FINAL
ENVIRONMENTAL IMPACT STATEMENT

Village at Po'ipū

Accepting Authority,
State of Hawai'i Land Use Commission
Docket No. A05-761
Eric A. Knudsen Trust

November 2006

Figure 15
 U.S. Fish and Wildlife Service
 Critical Habitat Areas

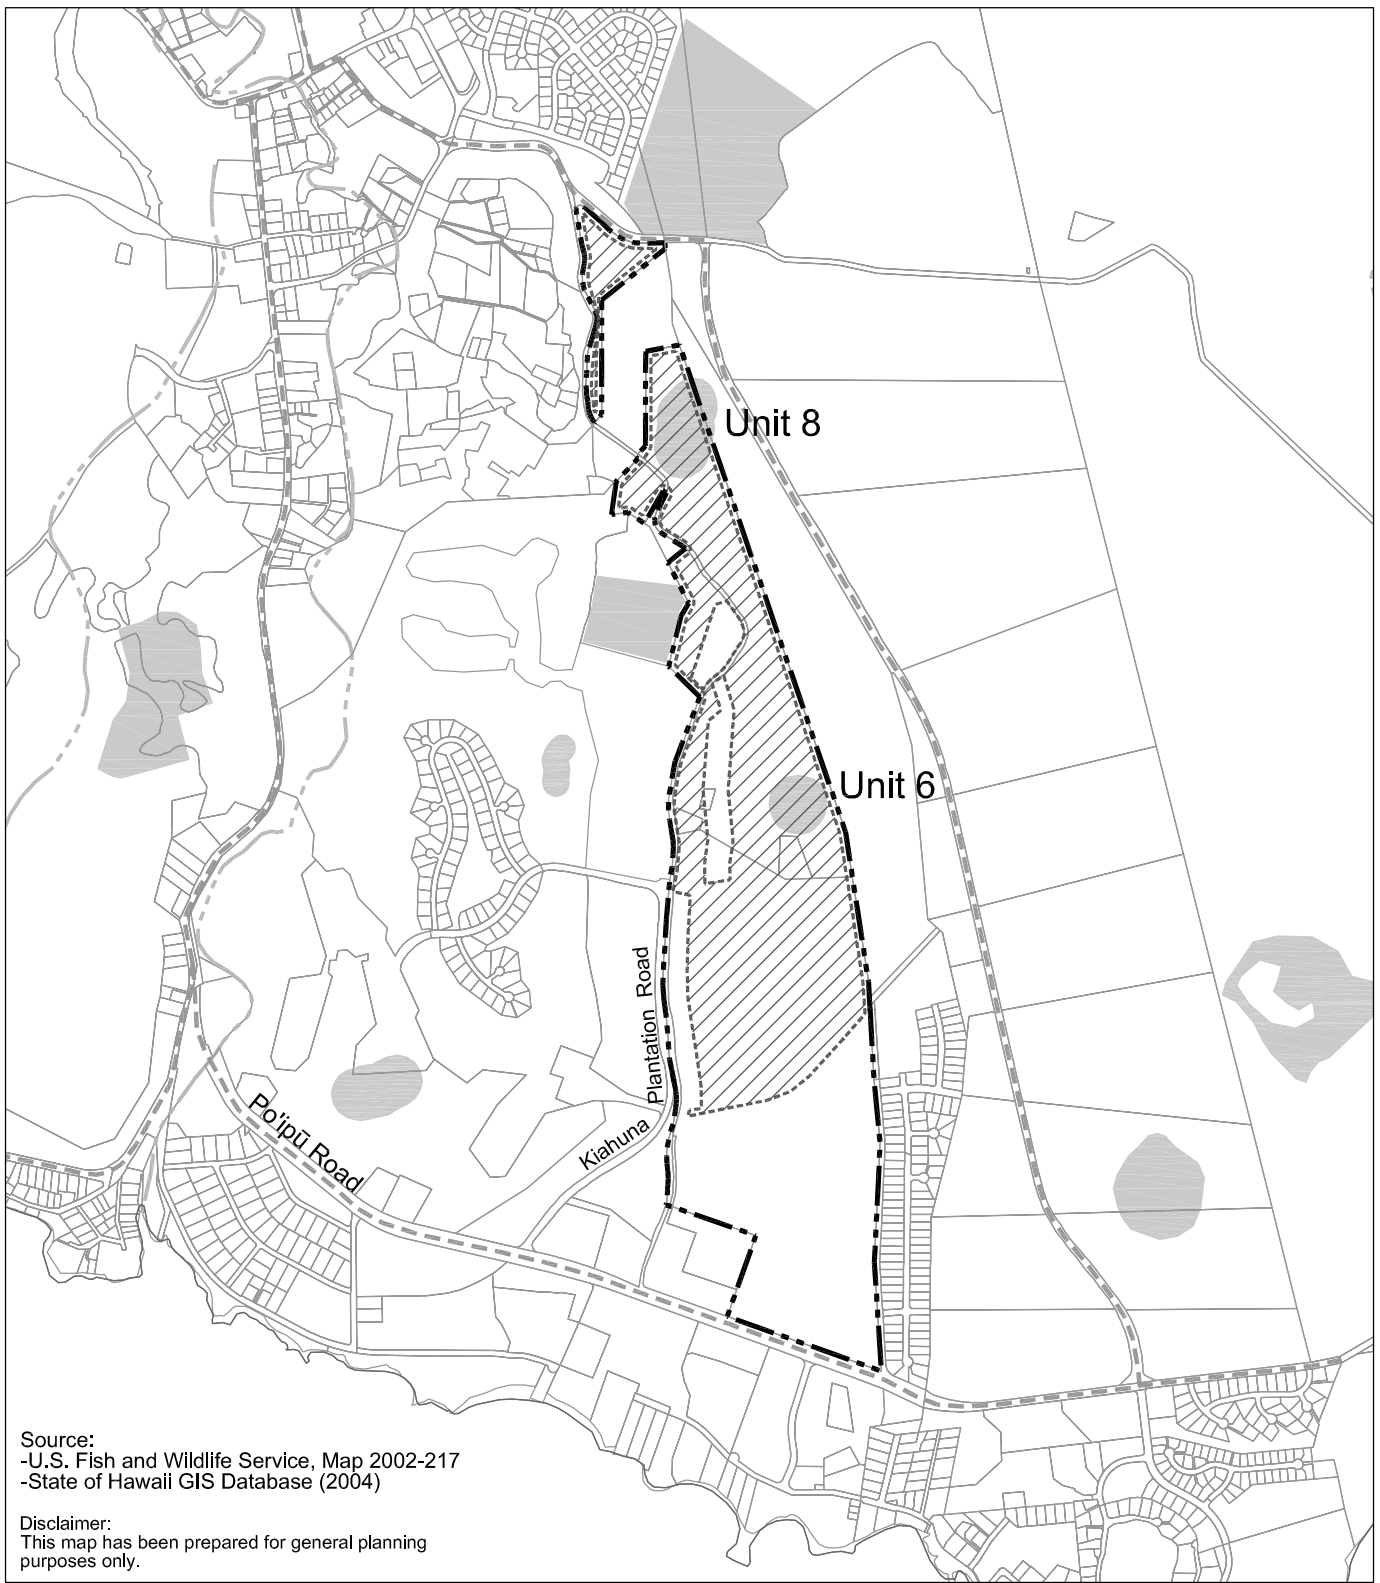
- 5) We note that the U.S. Fish and Wildlife Service has designated two areas within the Village at Poipu project site as "critical habitats" for the endangered Kauai cave wolf spider and amphipod. A 50-foot buffer within which no development will occur is planned to protect these habitats, which will be preserved as archaeological sites. Petitioner intends to landscape the areas with native plants to improve possible habitat conditions for these endangered invertebrate species. To the extent that their existence within the designated areas is currently unknown, we believe that consideration should be given to conducting a survey before proceeding any further with the entitlement process to (i) confirm whether these species are, in fact, present in the designated areas as well as in other portions of the petition area; (ii) determine the extent to which they will be affected by the proposed development; and (iii) develop the appropriate actions to mitigate any potential impacts. Until then, we believe that this matter should be identified as an unresolved issue in the Final EIS.

Response: The archaeological inventory survey prepared for the project site in 1991 delineated the full extent of the lava tubes and this is shown in Figures 3 and 16 of the Draft EIS. The critical habitat unit areas as shown in Figure 15 were established by the US Fish and Wildlife Service (USFWS). Fifty-foot buffers will be provided around the delineated lava tubes as shown in the conceptual master plan for the project and will be protected as archaeological preserves in which no buildings will be constructed. In addition, native plants will be planted within these areas to improve potential habitat conditions for the two endangered species.

Figure 3
CONCEPTUAL MASTER PLAN
Village at Po'ipū
PBR & AFFILIATES TRUST

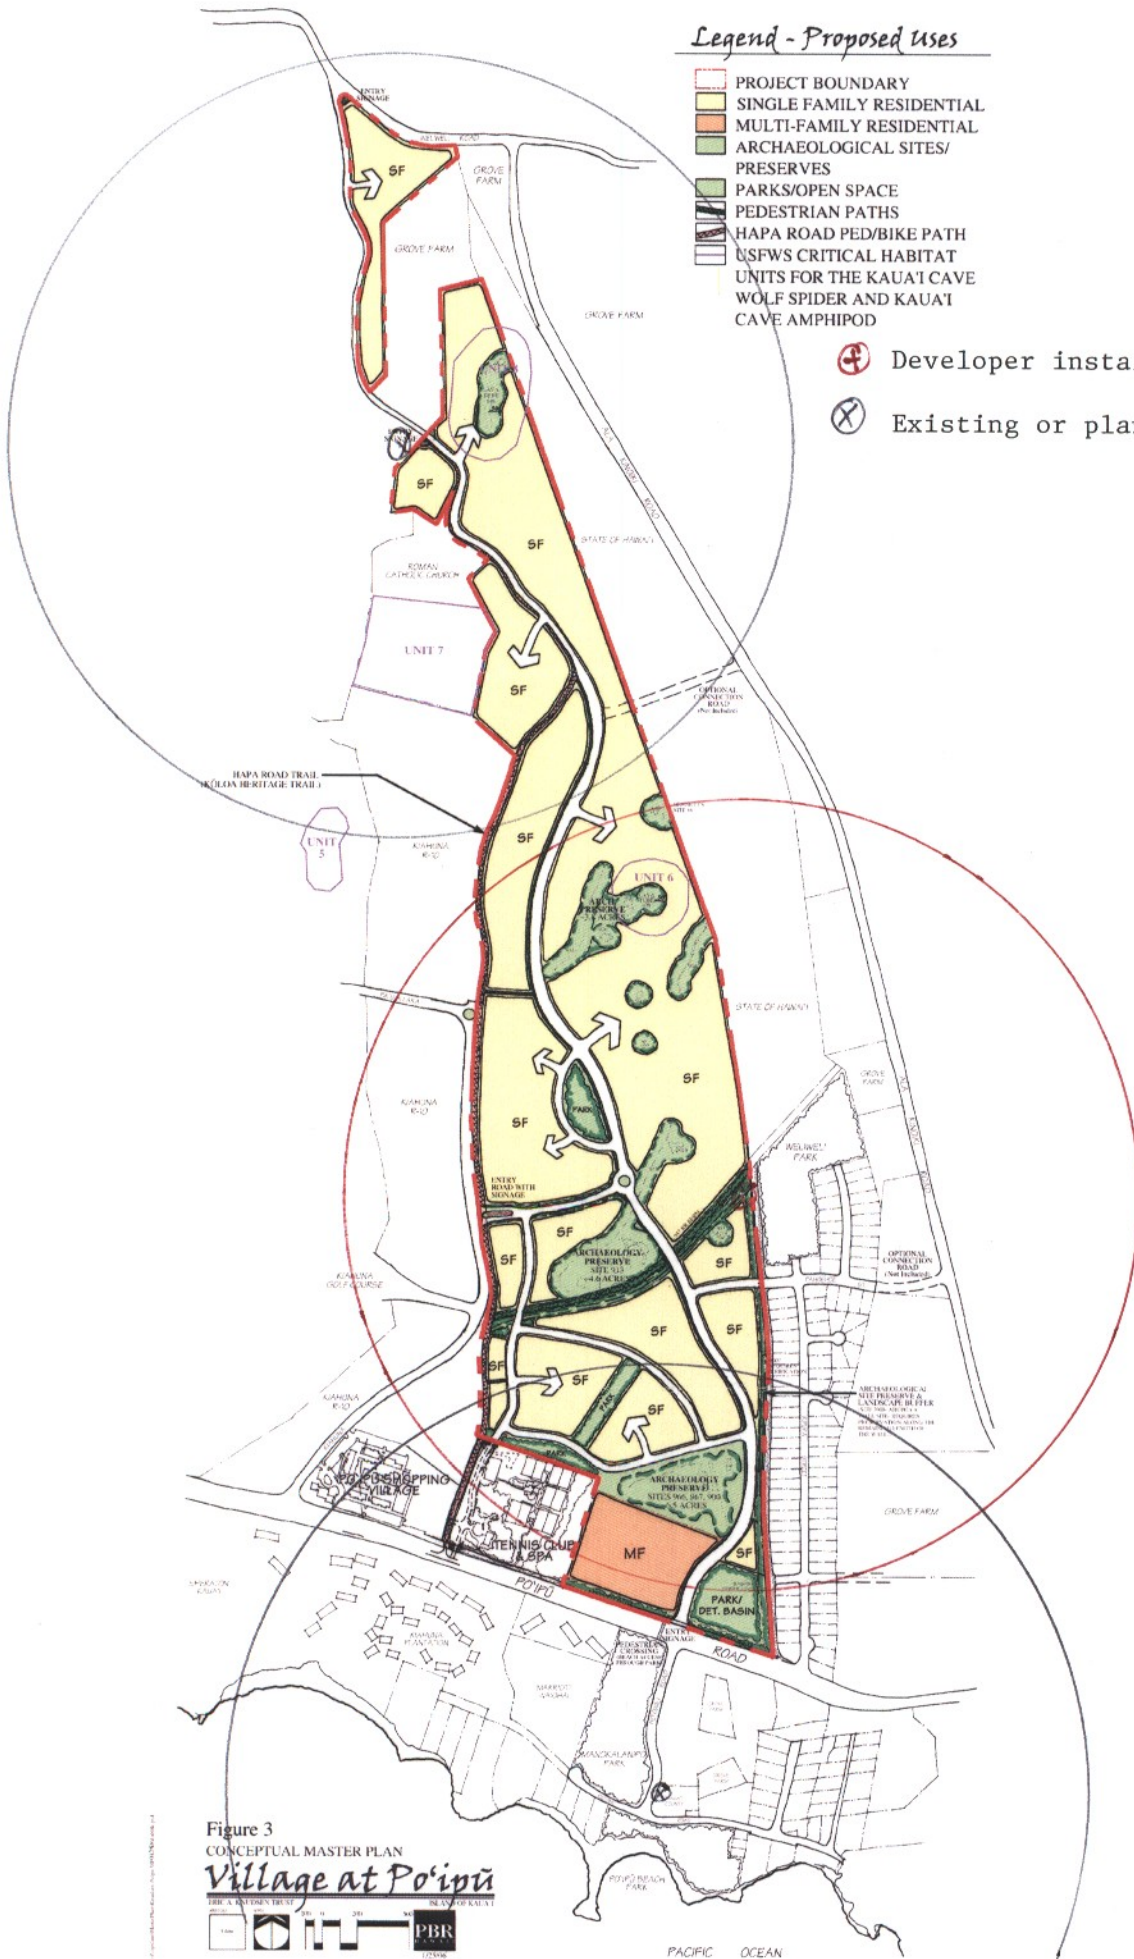
Thank you for the opportunity to comment on this Draft Environmental Impact Statement (DEIS). Having reviewed the DEIS, it is requested that the developer install a solar powered 119 Dbc siren near Weliweli Park and the berm as shown in red on enclosed Figure 3.

The increase in the number of residential units and population housed in the area caused by the development of the proposed project and petition area requires additional civil defense facilities for the area. The State Civil Defense recommends the installation of a solar powered 119 dBc siren near Weliweli Park and the railroad berm as shown in Figure 17. This recommendation is consistent with the requirements for the petition area as well since the same physical project area would need to be served by Civil Defense regardless if the additional 98 units are permitted or not. The applicant will comply with this recommendation and install the siren as proposed.
